REQUEST FOR INFORMATION	DATE: October 27, 2016	NO.: RFI-337
--------------------------------	-------------------------------	---------------------

Project Name:	15051-Webster University Interdisciplinary Science Building	Project No.: 15051
---------------	---	--------------------

Subject: Room 407 floor box clarification

E0104.B

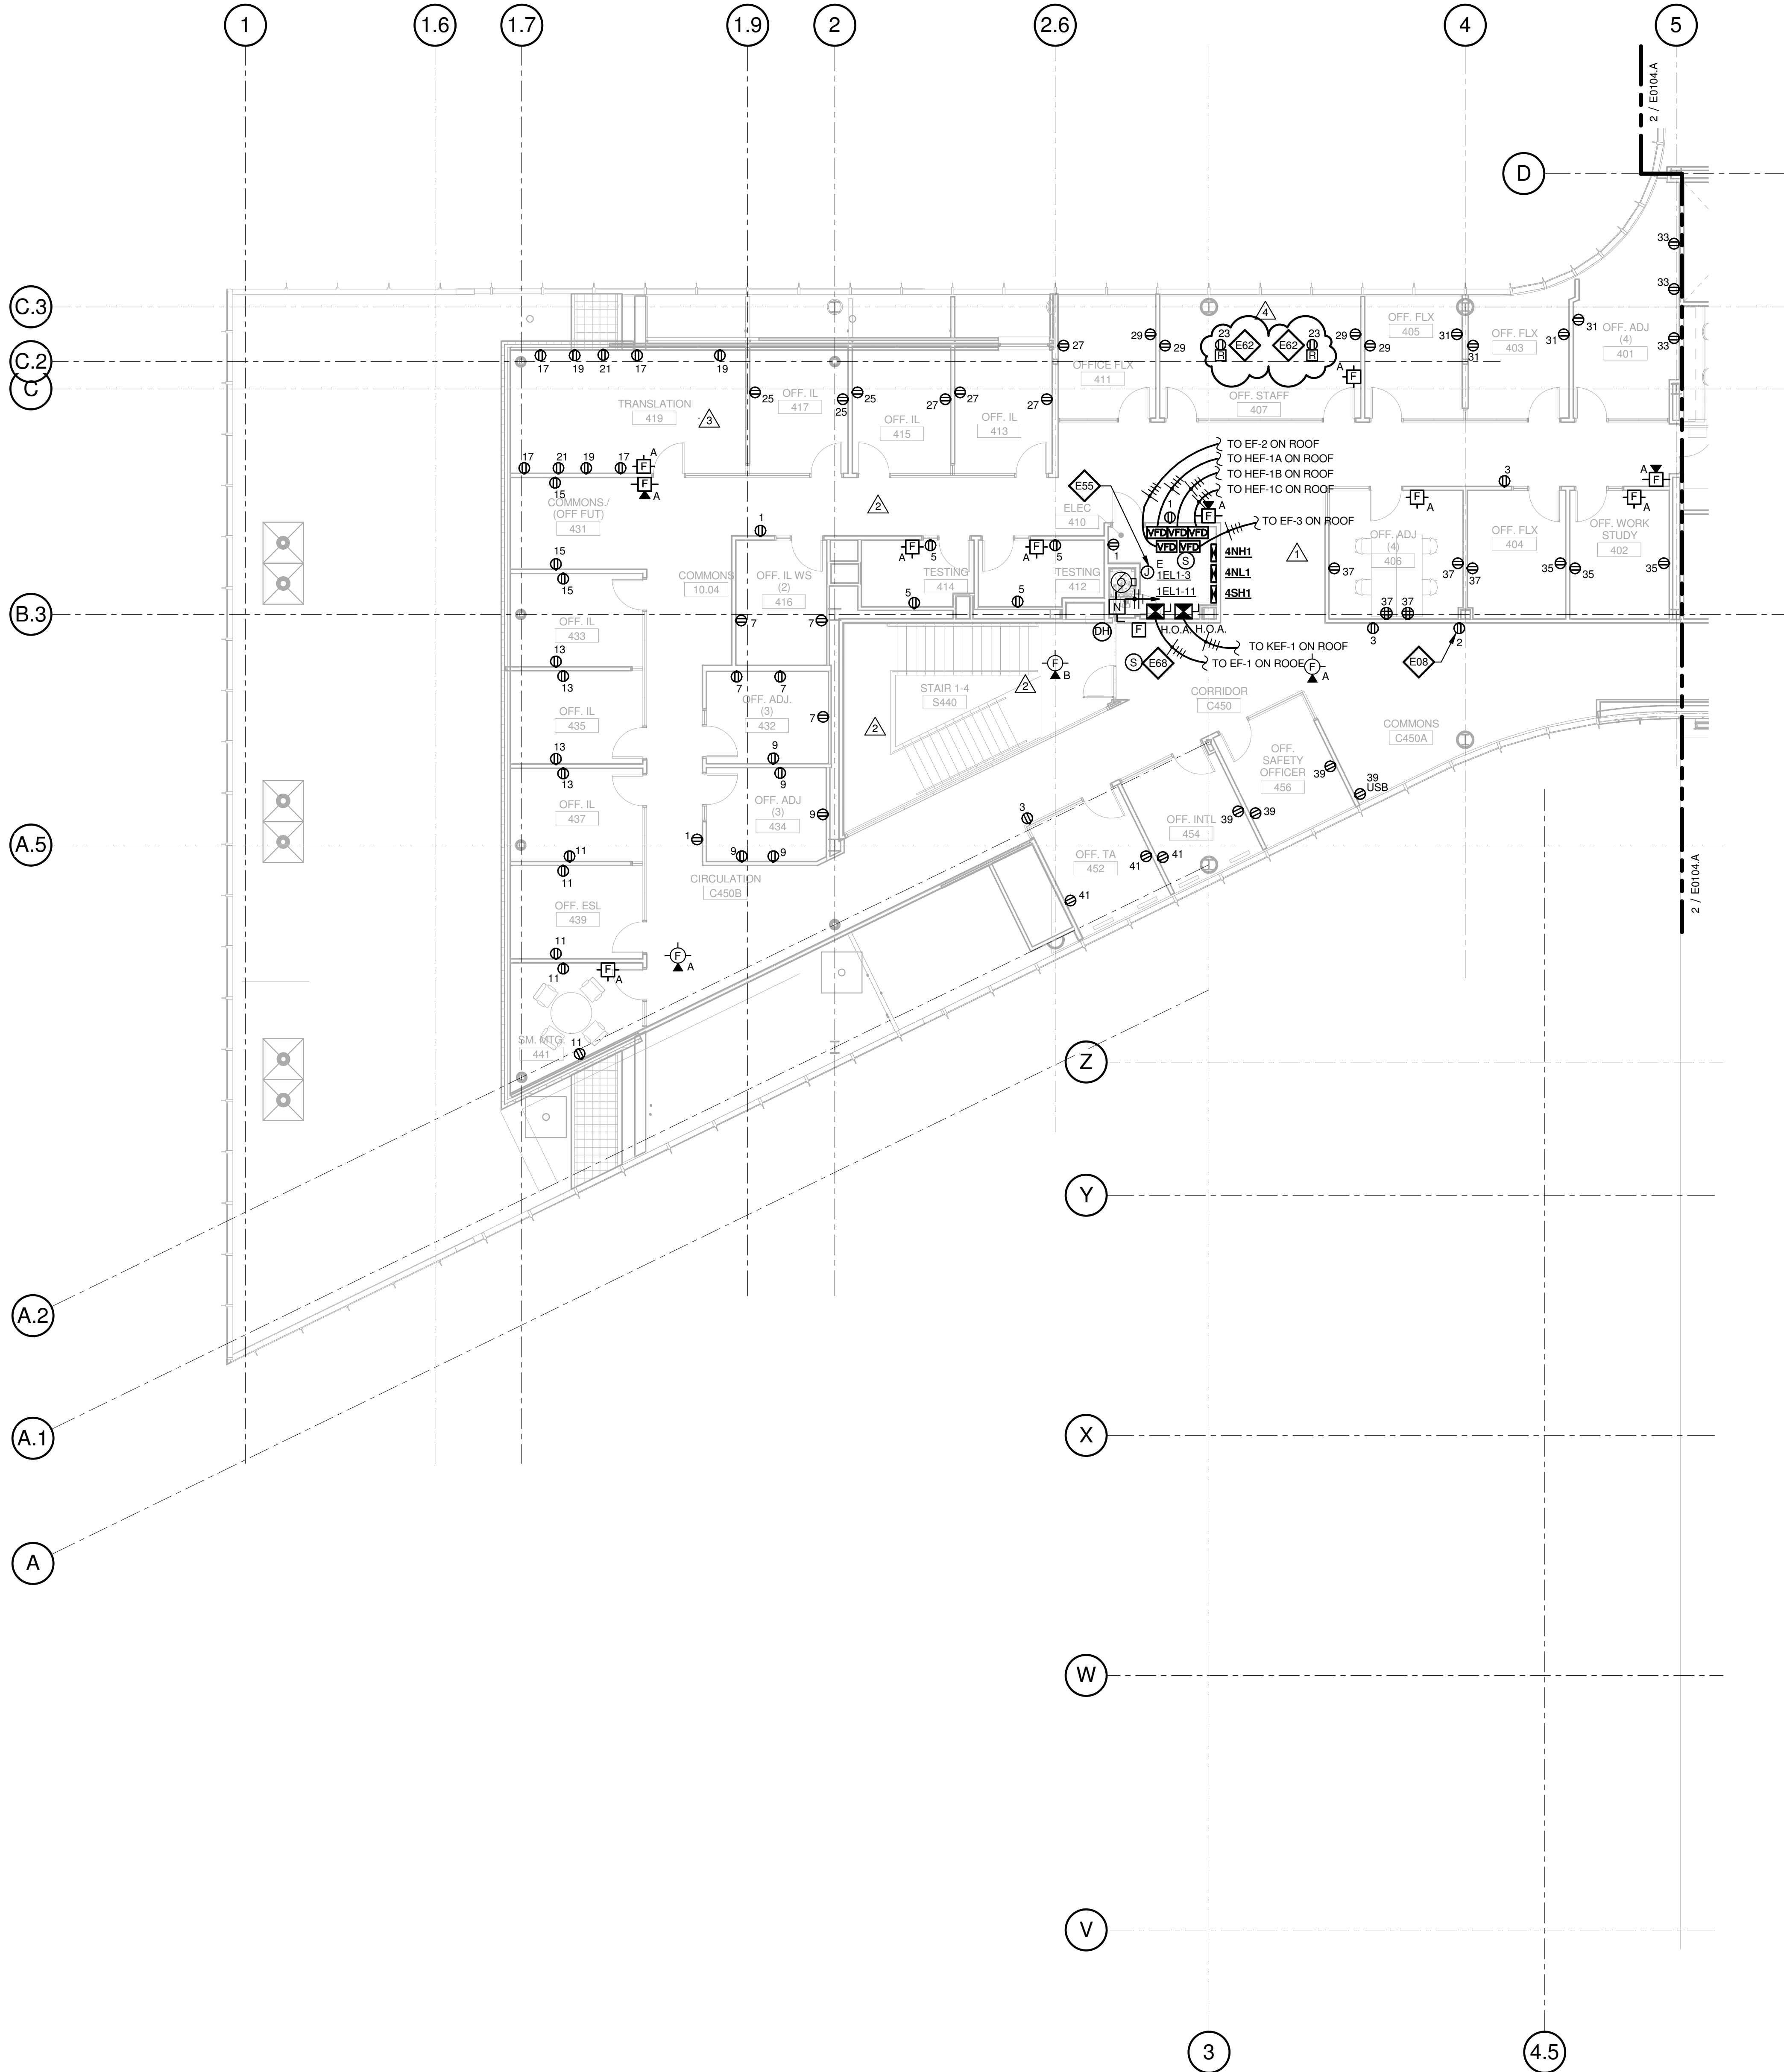
RFI 162 showed 2 floor boxes in room 407, this was never included in any electrical drawing change. Please confirm we are to follow RFI 162.

Provide two floor boxes as called for in RFI-162. See attached drawing update.
